**TIMOTHY V. FLYNN-O'BRIEN**

January 9, 2012

**RE: Project No. 1003859**

The application<sup>1</sup> should be denied. The application:

### TAB 3

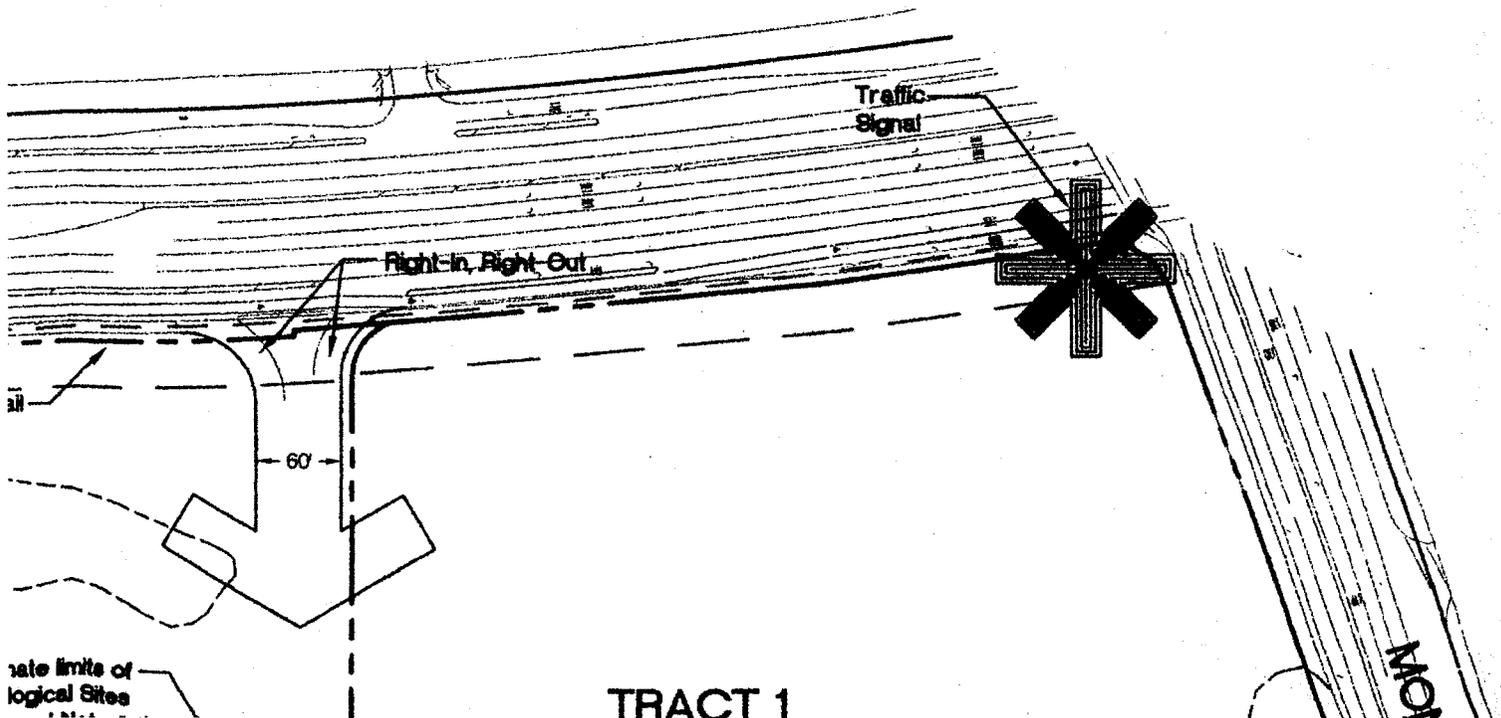
The proposed site plan proposes to use Tract 3 for the most intense C-2 use, that is, for semi truck parking and loading for the Big Box and for an area for truck access to the large retail facility loading docks and for center ingress/egress.

The creation of a separate tract for this area indicates that this area was not to be merged into a C-2 retail development.

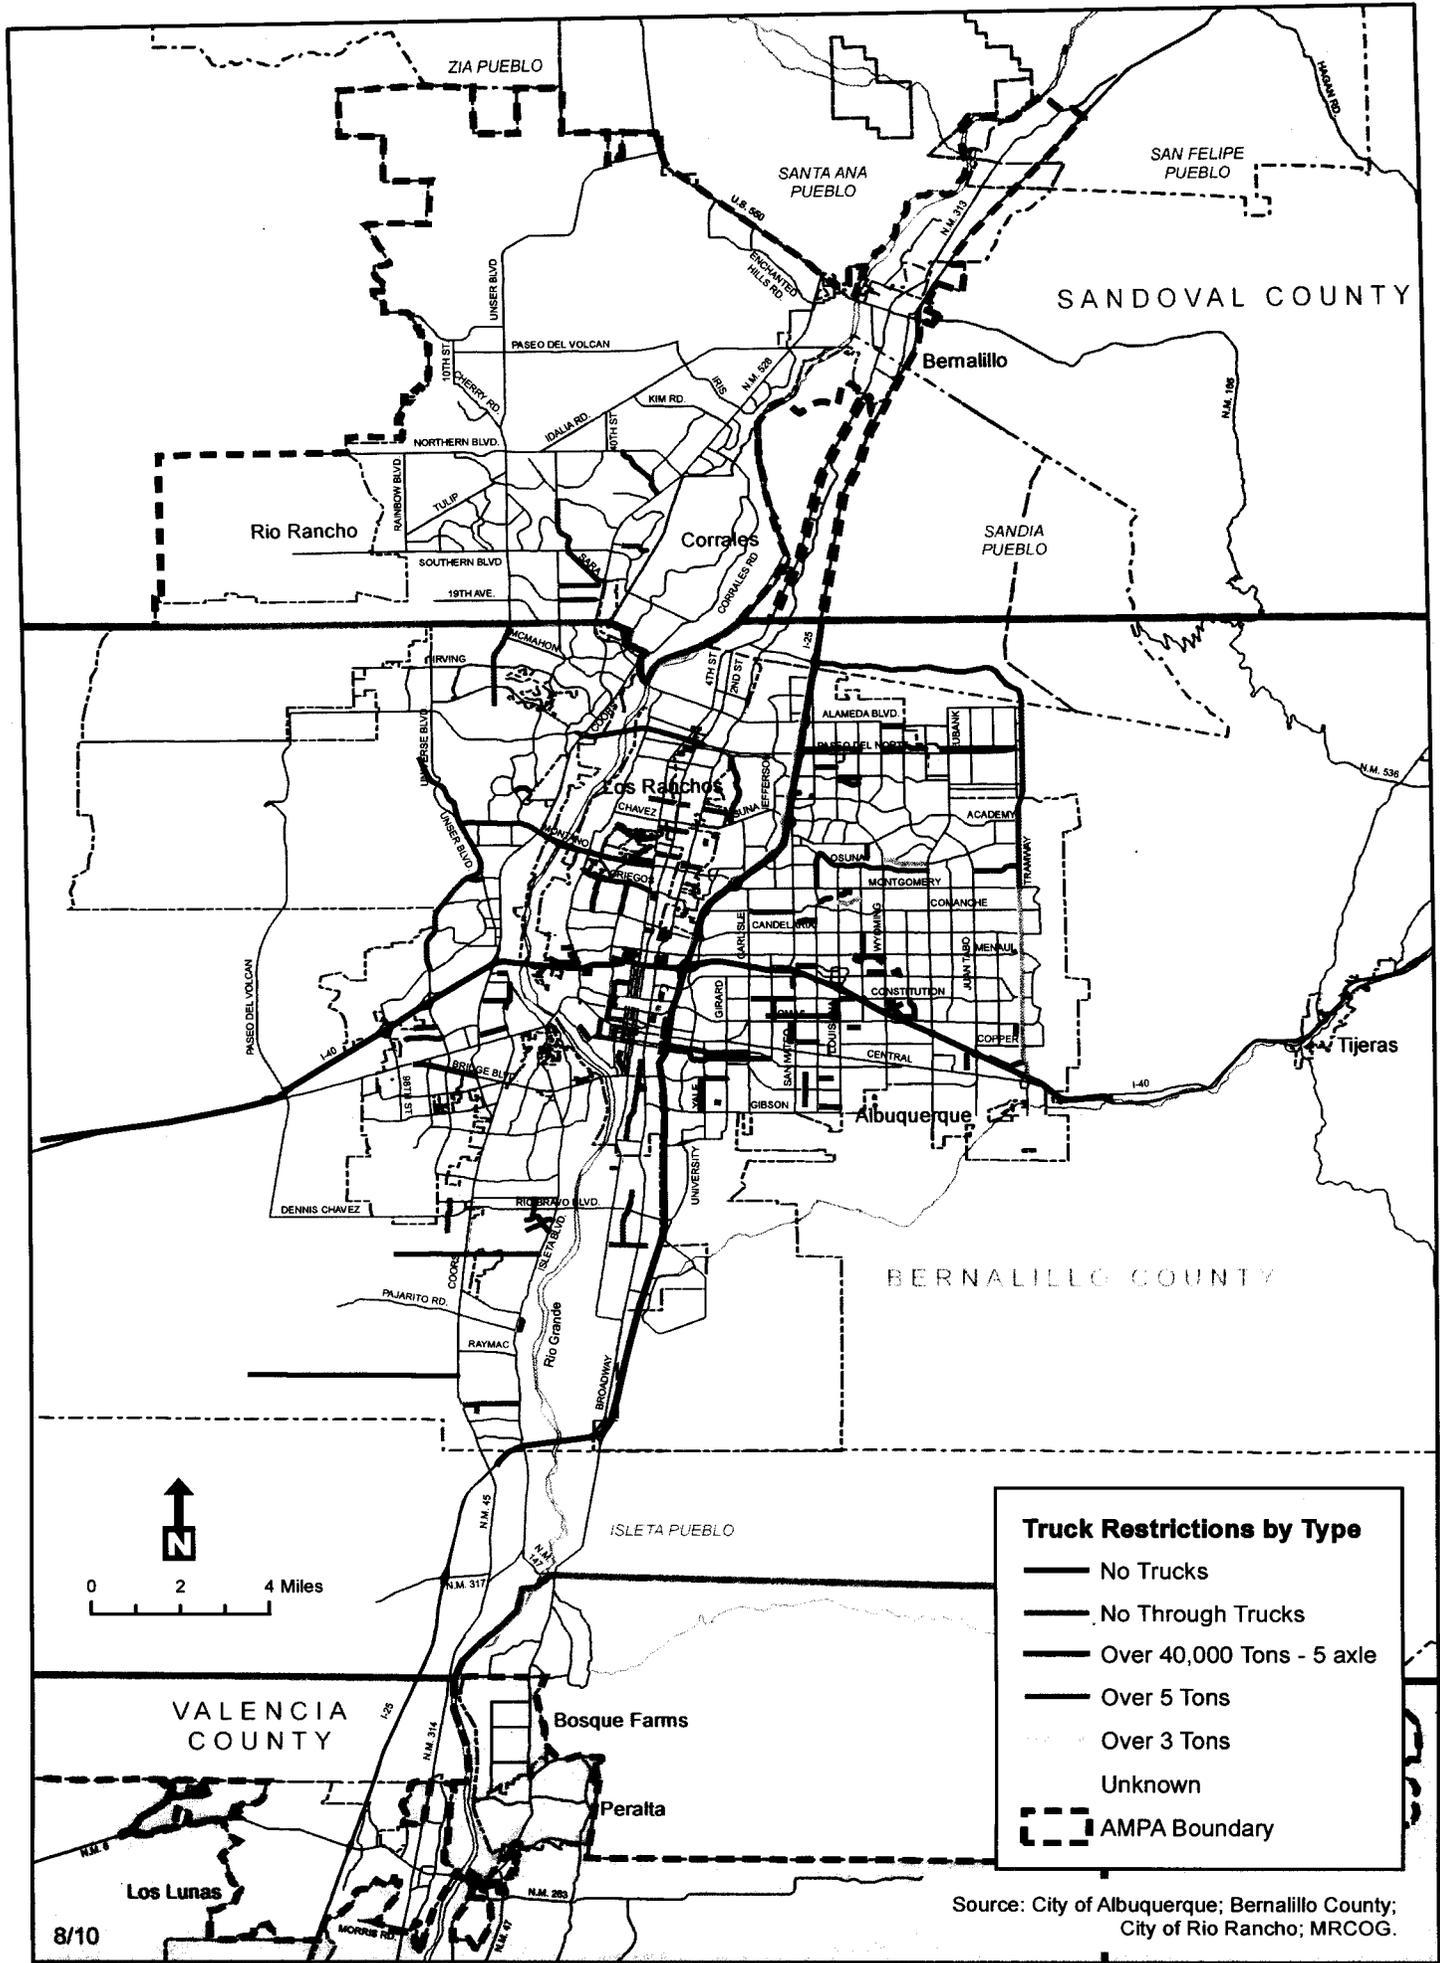
Truck Access. As a result of the Montano truck access restriction trucks cannot access the site from Montano. See 2035 Metropolitan Transportation Plan adopted by MRCOG. For truck traffic south bound on Coors there is no signalized access. Vehicles southbound on Coors can turn left at Mirandela but the turning radii for trucks is uncertain. As discussed under Tab 1 the zoning code requires primary full access that does not go through a residential neighborhood (Learning Road access requires traversing a residential neighborhood).

Trucks exiting the center therefore can only go north on Coors since all Coors exists are “right only”. Trucks wanting to go south on Coors would have to go through the residential neighborhood and use the signal at Learning Road. This funneling of traffic thorough a residential neighborhood is exactly what the Big Box Ordinance sought to prevent by requiring full access onto a four lane road.\* See Z.C. §14-16-3-2(D)(2).
